# TECHNICAL SERVICE BULLETIN

REF.: BODY  
 NO.: BO94-010  
 DATE: JULY 15, 1994  
 MODEL: SW

## CLIP FOR RADIATOR SUPPORT UPPER SEAL

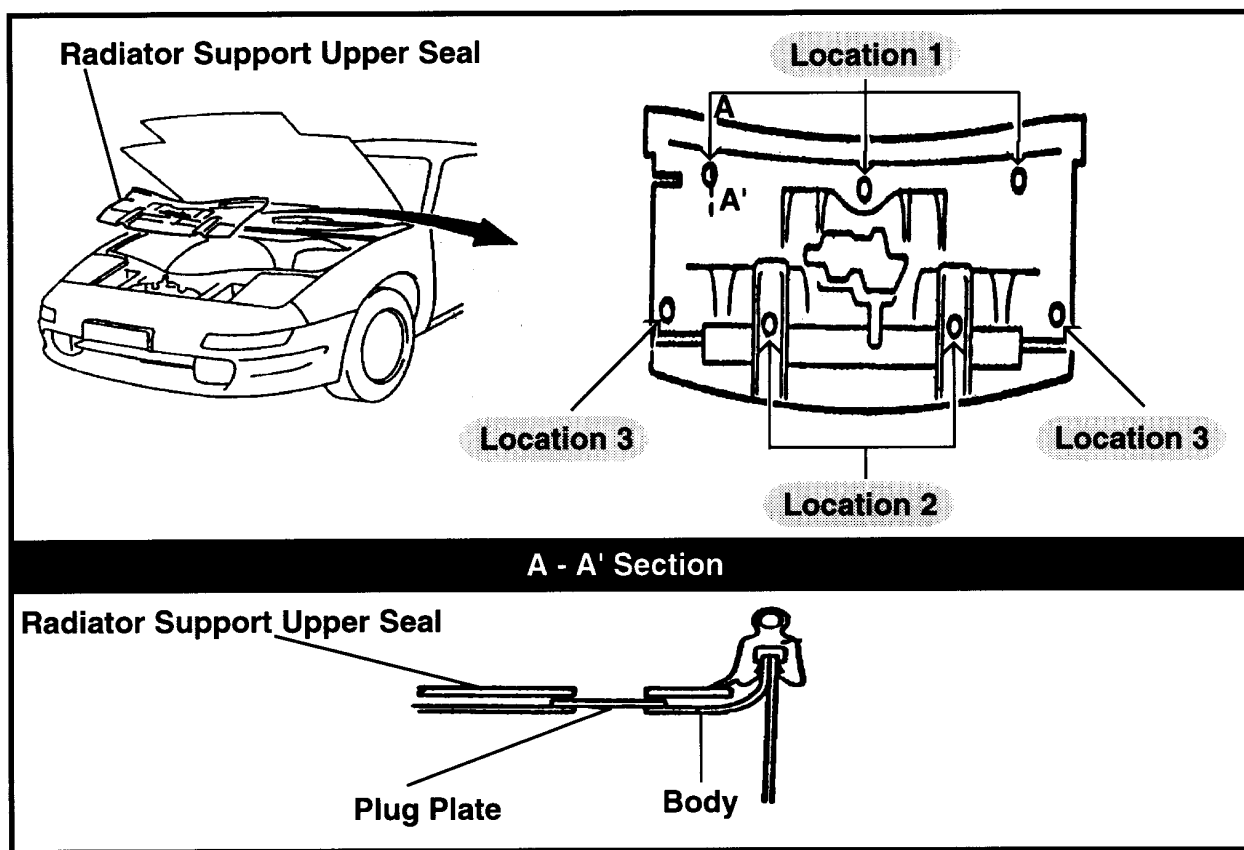
The quantity of clips used to attach the radiator support upper seal has been changed from 7 clips to 2, as shown below. In addition, 3 plug plates have been installed at location "1" holes.

Location 1	Location 2	Location 3
Previous	Clip x 3	Clip X 2	Clip X 2
New	Plug Plate X 3	None	Clip X 2
